1ST AND PIKE

DESIGN REVIEW BOARD | FEBRUARY 12 2019 | DPD #3028428

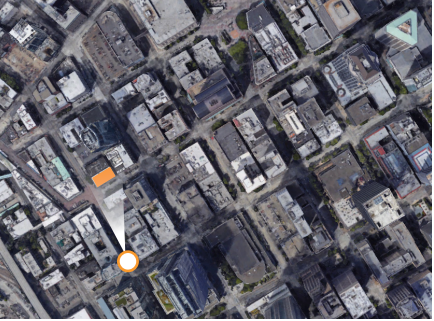
“The Board emphasized the importance of preserving views from the Pike Corridor to the Market entrance. Thus, the Board requested that the design team provide a view study inclusive of an alternative tower massing shown at a schematic level with a setback aligning with the Newmark Building at Pike Street for consideration. The view study should include numerous views from both ends of Pike Street between both the Pike Place Market and the Convention Center’s arch.”

The design team has performed a view study looking down Pike Street from the Convention Center to Pike Place Market, comparing the tower with 9’ and 15’ setbacks. The studies show there is no considerable benefit by increasing the setback on Pike.

PIKE STREET ELEVATION

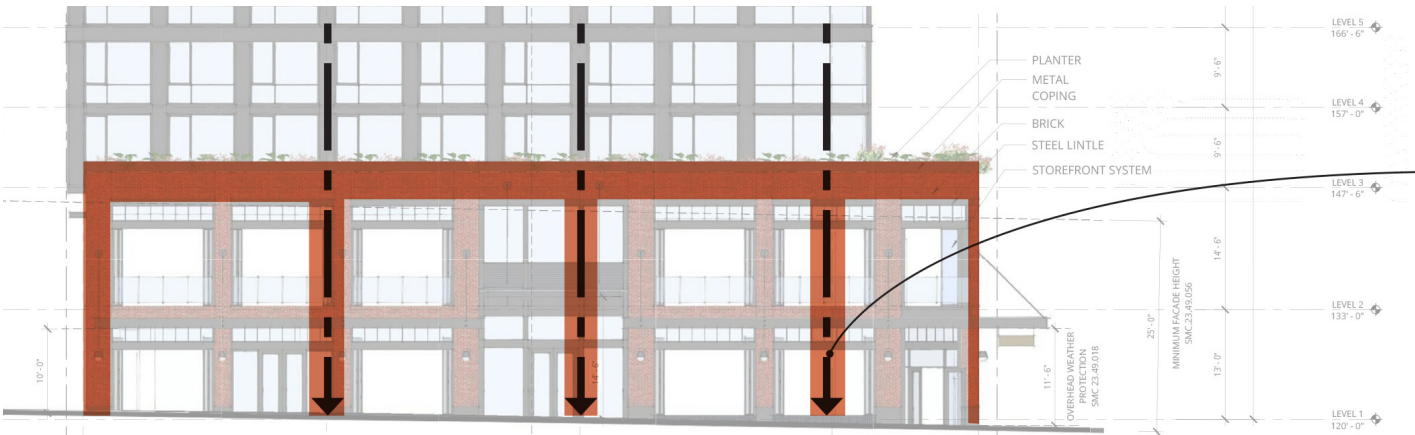
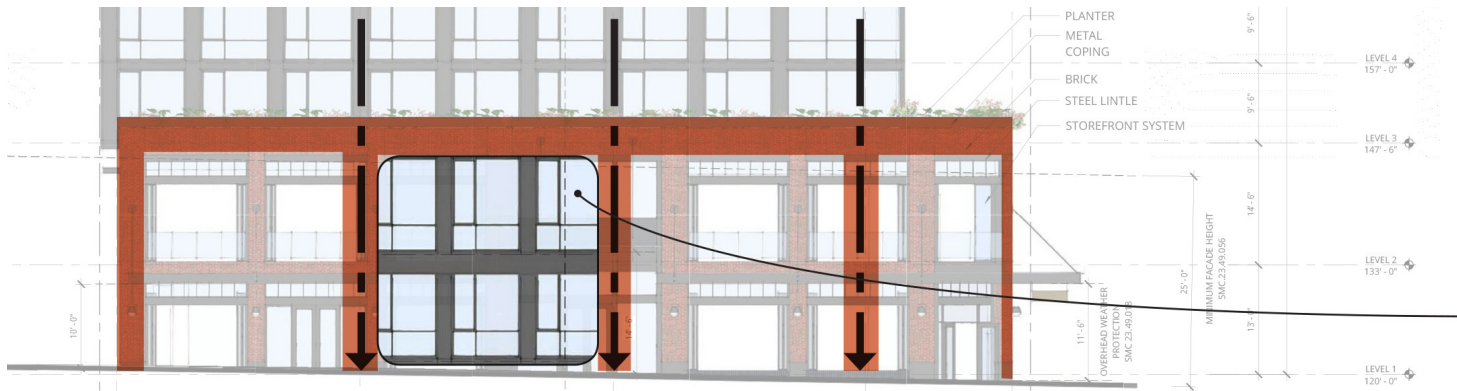
“The Board supported the distinct brick two-story podium. The Board favored the operable windows at the 1st and 2nd floor levels; and the increased glazing at the alley. The Board reviewed two hotel lobby entry options and stated a preference for the traditional hotel entry design within the brick base.”

The design team has made some updates to the podium keeping the Board’s comments in mind. Modifications to the bay width have been adjusted to better to respond to the building’s structure and to integrate the tower design. Steel within the bays further integrates the podium with the tower. The off-center hotel entry increases visual transparency into the lobby space and provides better operations for the small floor plate.

The operable windows on Level 2 are similar to those found on the Corner Market Building and help visually connect the podium design to the historic Neighborhood. Operable windows were removed at Level 1 to support retail function.

The exterior brick pilasters have been aligned with the tower structure. This helps to unify the building's programmatic and structural elements.

The glass and steel expression of the tower is introduced at the street level to integrate the two distinct massing elements of the building.

Proposed Canopy Design at DRB

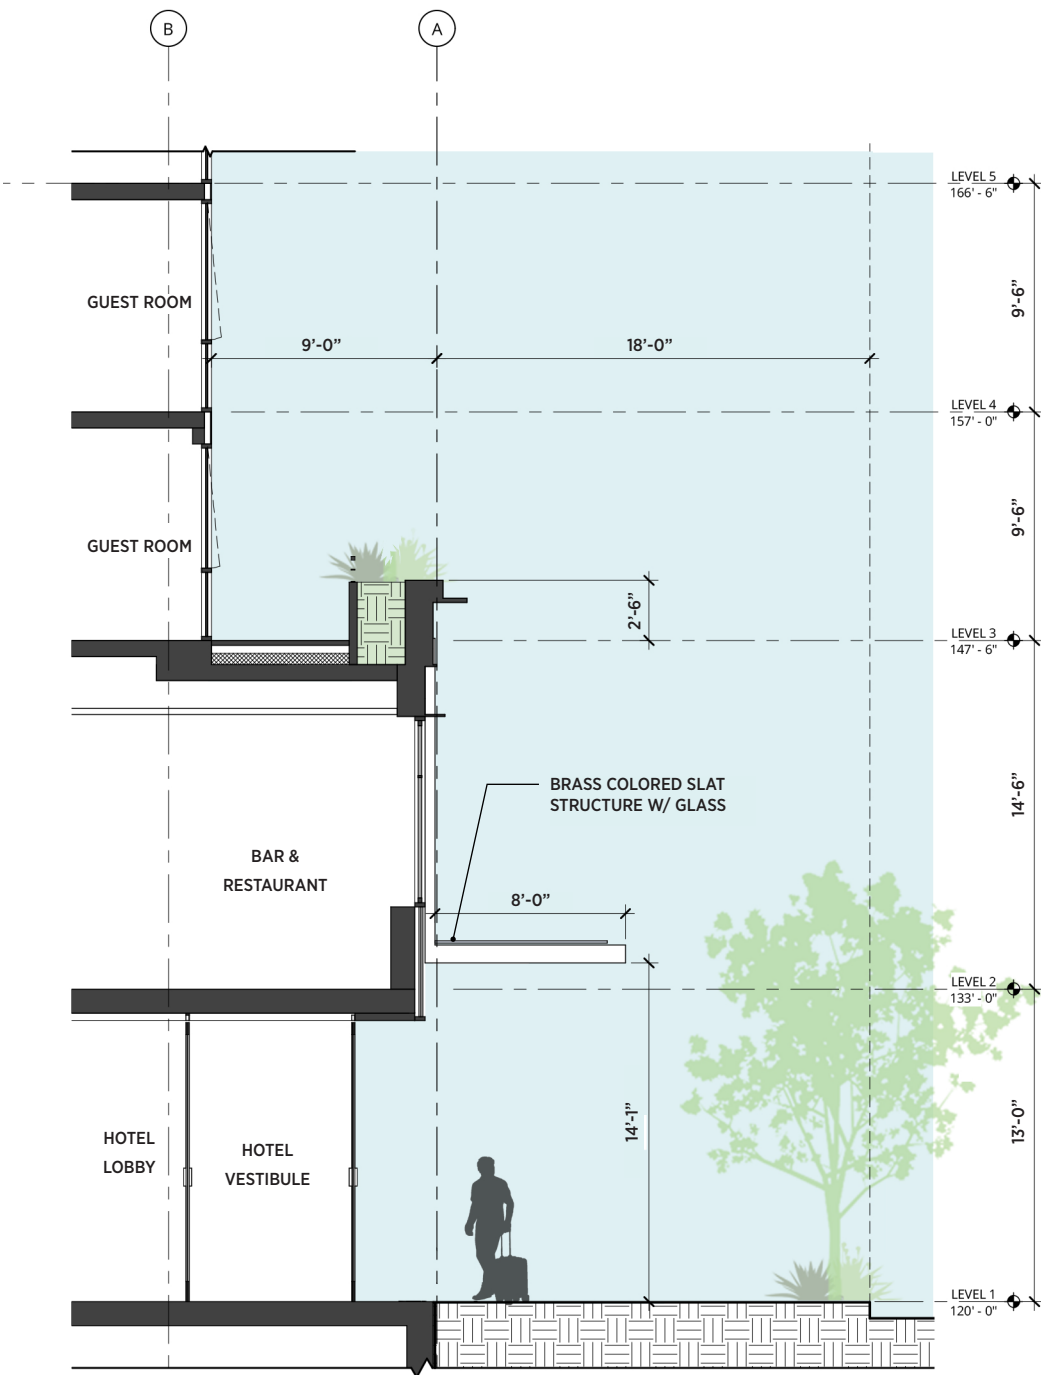
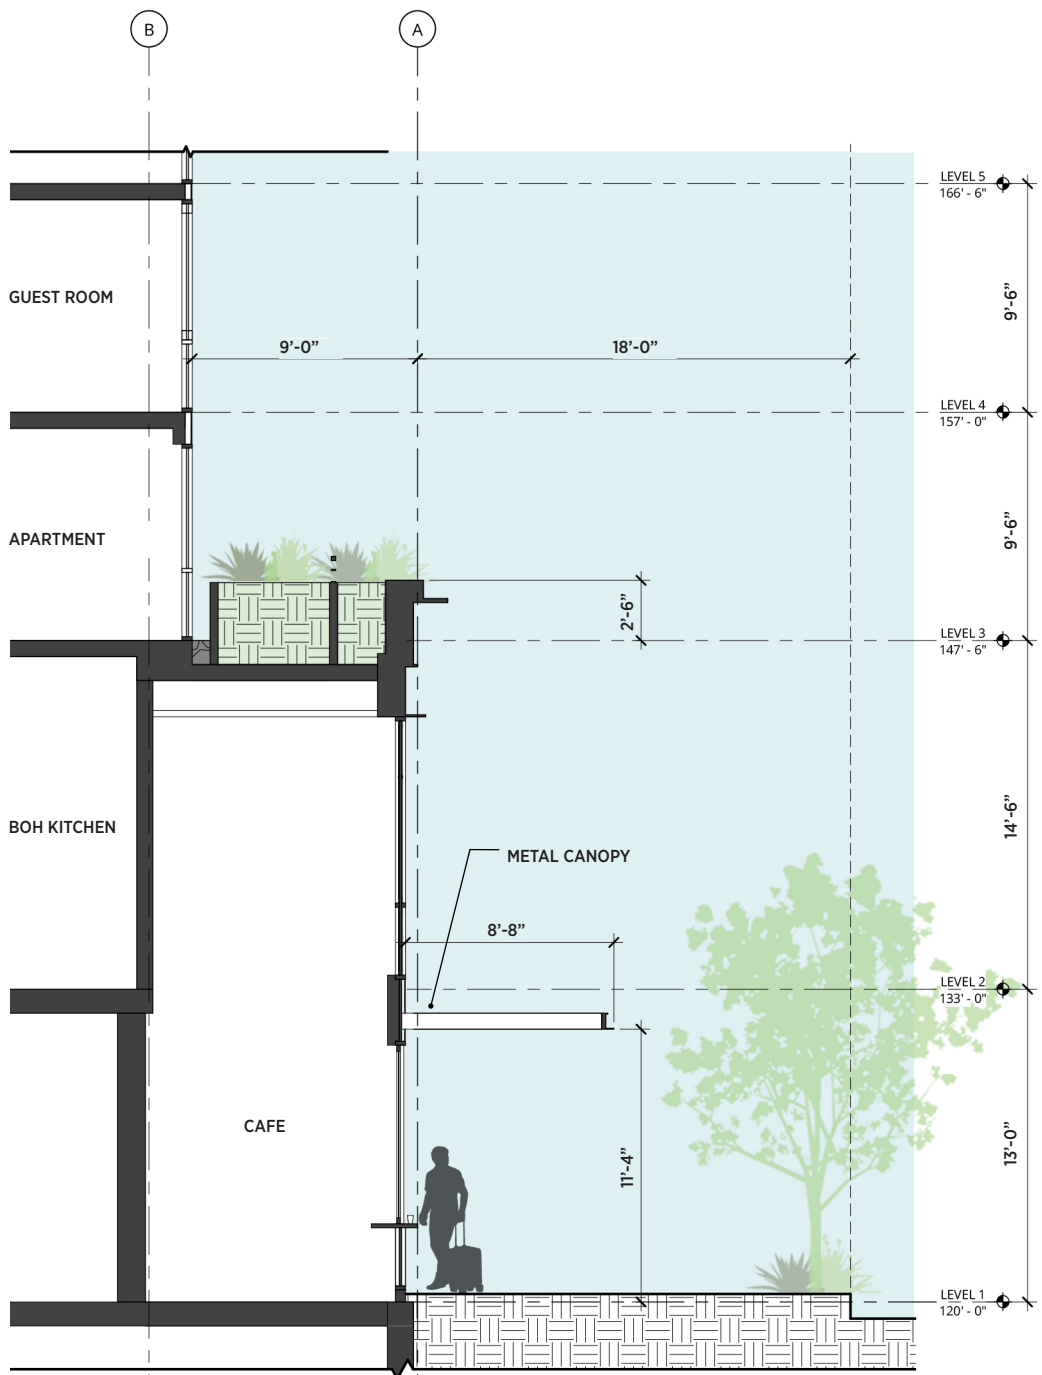
“The Board also had positive comments pertaining to the canopy design.”

A simple canopy with a C-channel edge detail is proposed for the retail and reinforces the canopy design of the surrounding buildings. The hotel entry has a signature brass colored canopy to distinguish it as the main building entry, while providing an opportunity for integrated signage.

BRICK SAMPLES FROM MARKET NEIGHBORHOOD

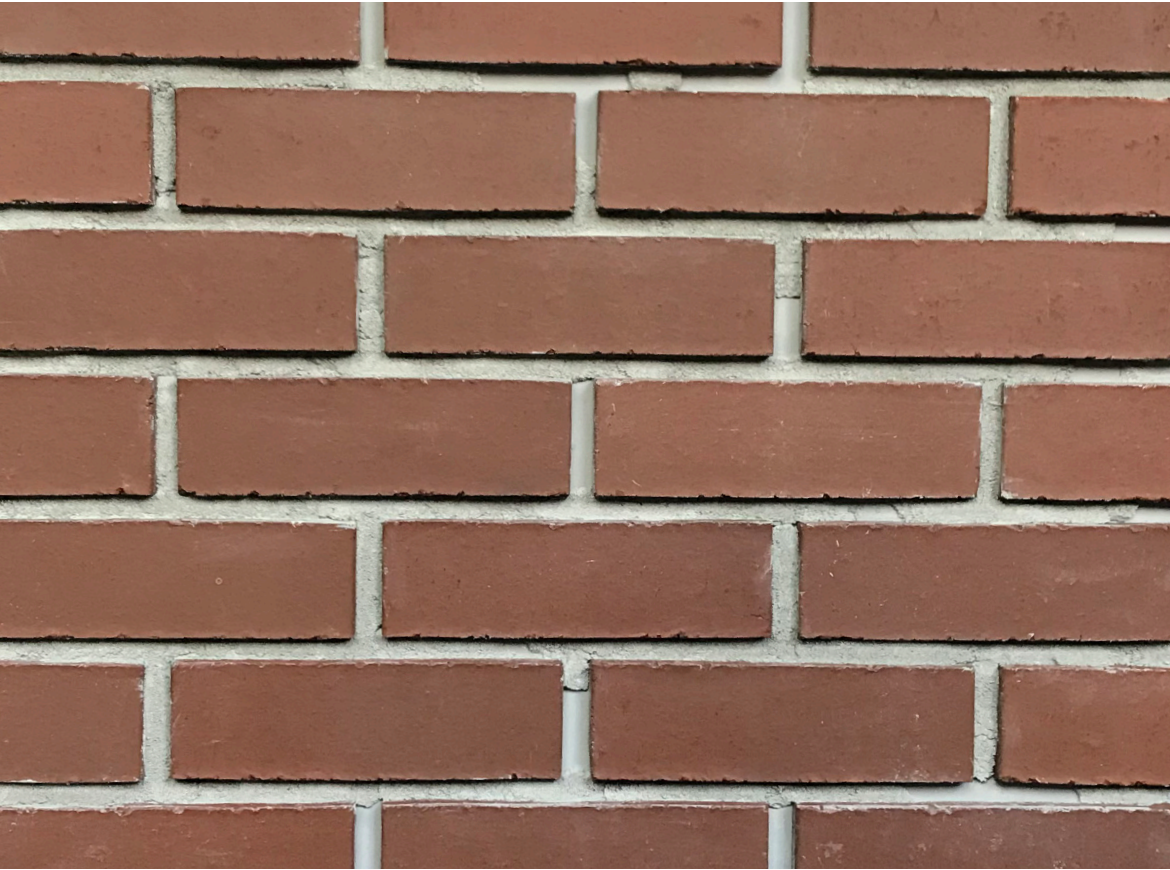
“The Board advised the design team to thoughtfully study brick examples found throughout the neighborhood and provide multiple high-quality brick samples and pertinent neighborhood images.”

The images on this page represent both brick found in Seattle and inspirational images for the project. The opposite page shows brick examples found within a few blocks of our site. The preferred brick for the project honors the current Hahn building brick and fits well into the neighborhood context.

Preferred Design at DRB
Alley Corner, Looking Southwest

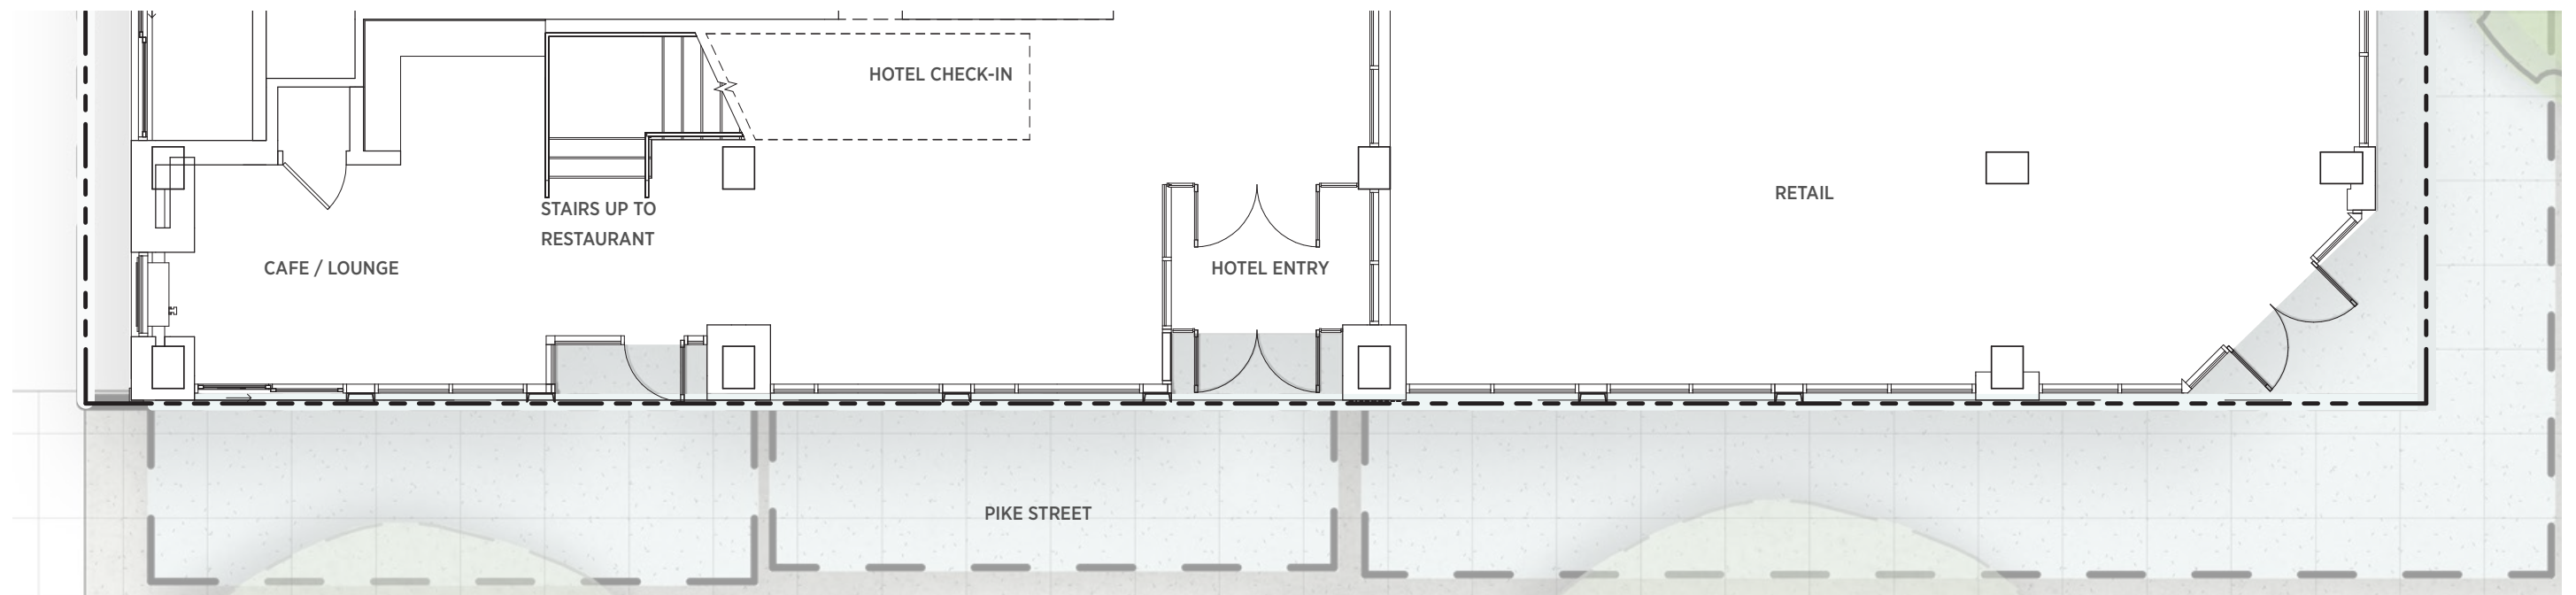
“The Board requested a resolution for how the tower interacts with the podium at the alley and asked the applicant to provide design options that address this concern appropriately. Ultimately, the Board would like to see the brick material extended to the podium parapet so the brick podium will read as a coherent element.”

With the preferred design, a gasket separates the tower and the podium massing and allows the continuation of brick to wrap the corner into the alley.

Current Tower Design

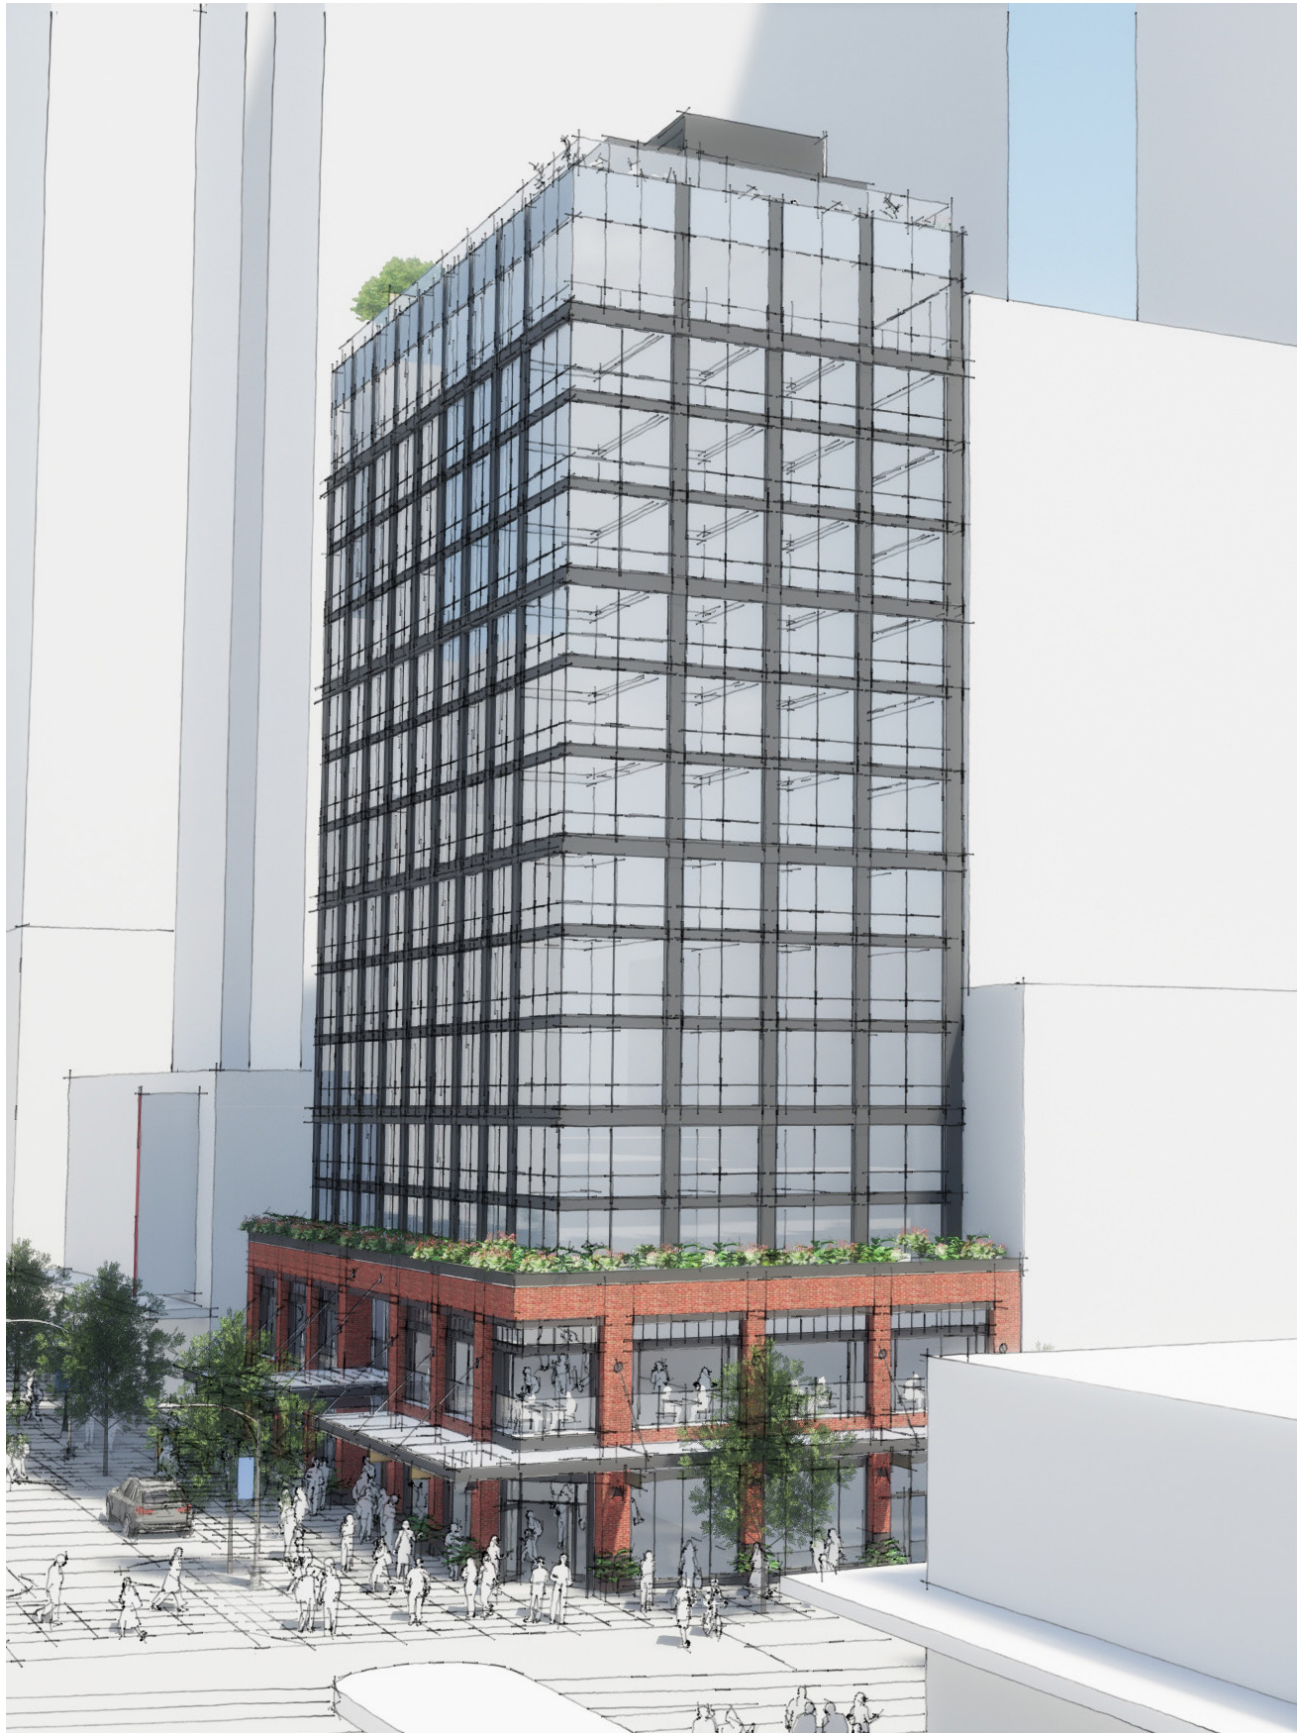
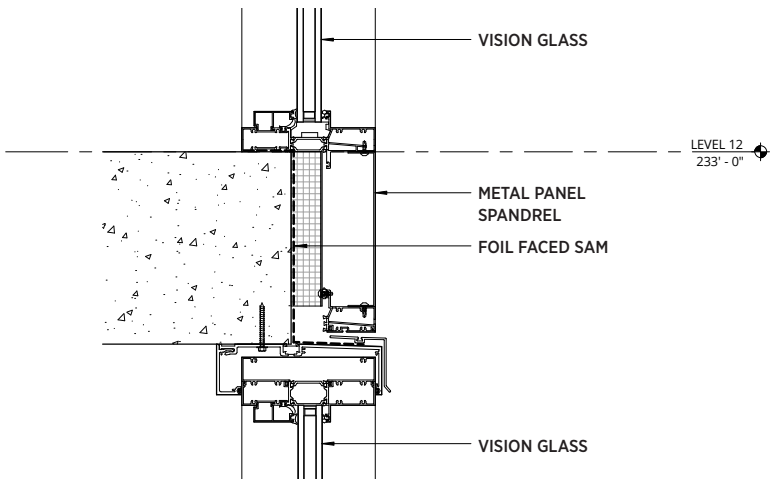
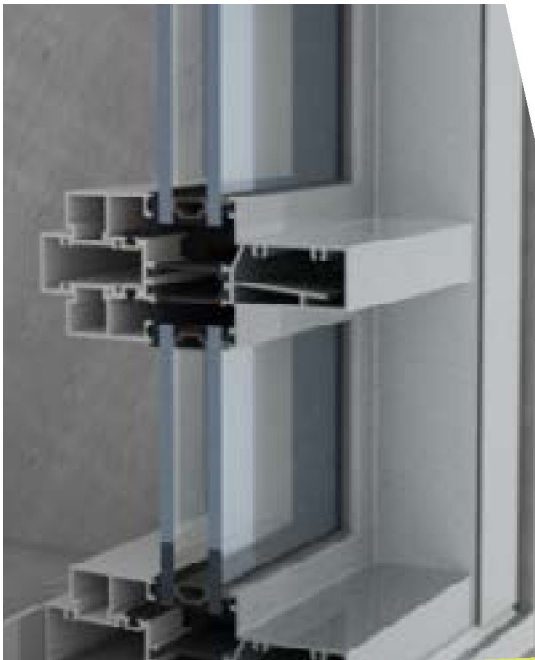
“The Board supported the glass and steel skin concept for the tower. The Board stated that the tower design needed more refinement and requested that at the Recommendation phase, they would like to review alternatives for the tower that include a more frame-like expression to tie the design to back to the simpler straightforward buildings at the Market. Completing the frame at the corner at the top edges would meet the intent of the Board’s direction.”

The design team has carefully studied the tower cladding. The preferred option incorporates the Boards direction to emphasize the frame-like quality, while also ensuring that the tower is well integrated with the base and honors the character of the market neighborhood.

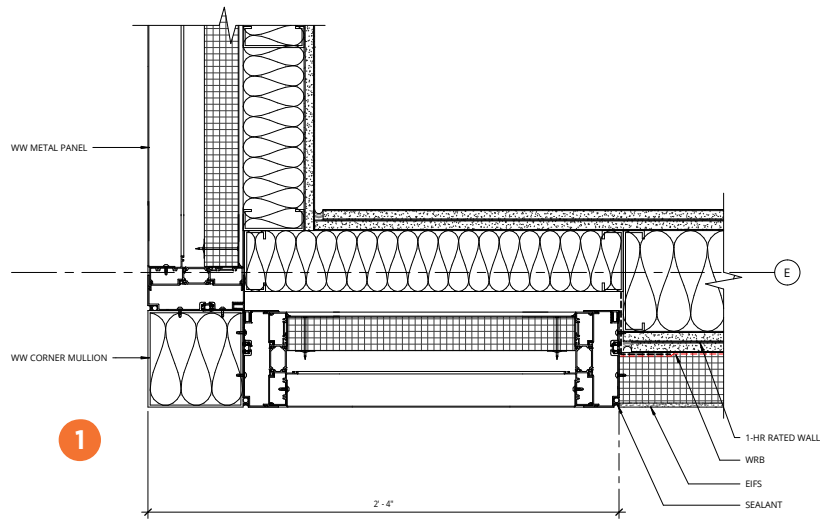
“The Board’s comments pertaining to the south party wall facade were very positive. The Board liked the brick base. The Board supported the applicant’s intent to consider a temporary artwork feature on this facade.”

The South facade is a party wall and has been designed to compliment the 1st Avenue elevation and the alley elevation. Score lines in the EIFS continue the rhythm and pattern from the street-facing facades. Careful detailing at the corner help unify the different facade treatments.

There is a strong possibility of development on the neighboring lot. If the parcel to the south does not begin the MUP process within 24 months of the hotel opening, the owners will provide art for the south-facing property line wall.
